Access Compliance Report Public Rights-of-Way (Curb Ramps)

Intersection ID: 17865 Main Street: OVERHILL_RD Cross Street: S_WENDOVER_RD Location: NW

ADA ID: 90EA33C9BEF8 Ramp Type: PerpDiag Initial Pass/Fail: Fail Overall Compliance: No Severity Score: 12.5

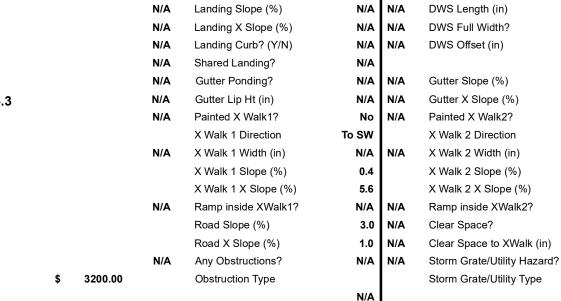
Not Found, R304.5.3

Remove & Replace Curb Ramp With Two New Directional Ramps or Equivalent.
